SERVICE BULLETIN

DATE: 1 JULY 1982

REPLACEMENT OF INTERCOM (ICS) SWITCH AND JACK ASSEMBLY

All 500 Model 369H Series Helicopters

Figure 1. Rework of Intercom (ICS) Switch and Jack Assembly into an Adapter Cable.

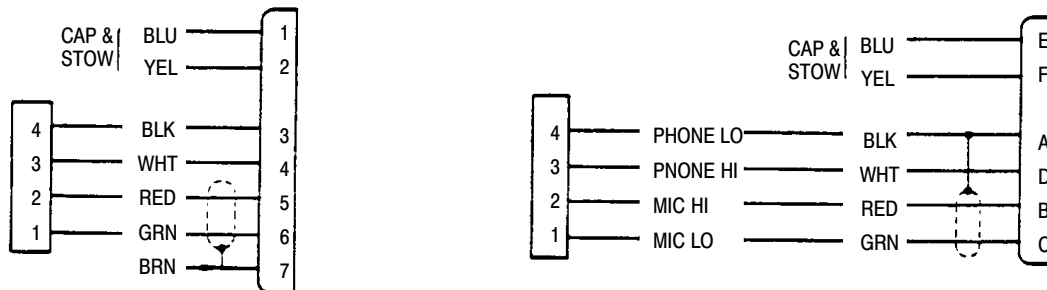
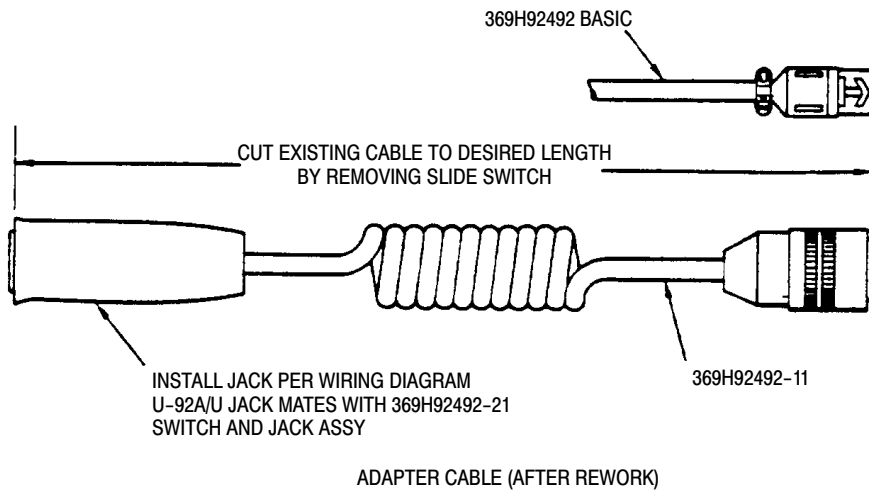
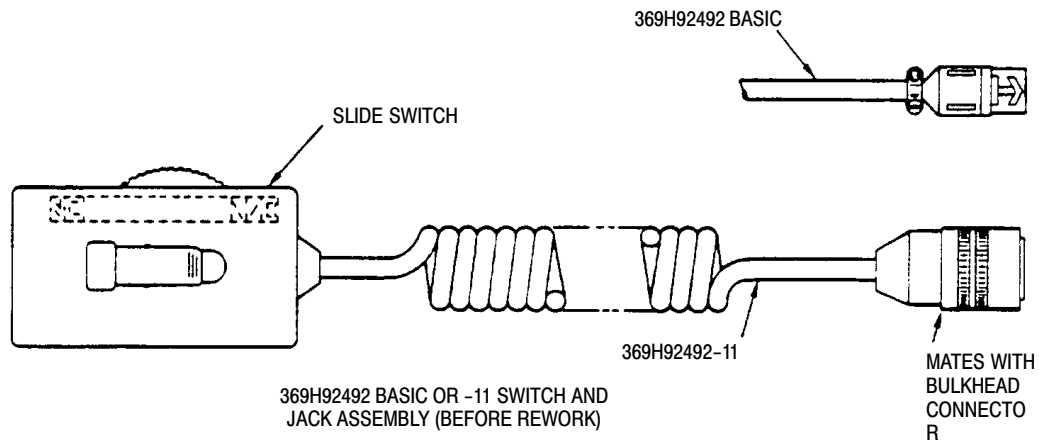
- (3). Rework switch and jack assembly into adapter cable as follows (see Figure 1):
 - (a). Cut cable of switch and jack assembly to desired length and discard switch.
 - (b). Remove insulation from wires in cable and solder wires to new jack. (Refer to appropriate wiring diagram in Figure 1.)
- (4). Connect adapter cable to bulkhead connector in helicopter.
- (5). Connect new switch and jack assembly to adapter cable.
- (6). Connect headphone to new switch and jack assembly.
- (7). Check intercom system (ICS) for proper operation. (Refer to 500 Series HMI, Appendix A, Group 7.)
- (8). Record compliance with this Service Information Notice in Compliance Record of helicopter Log Book.
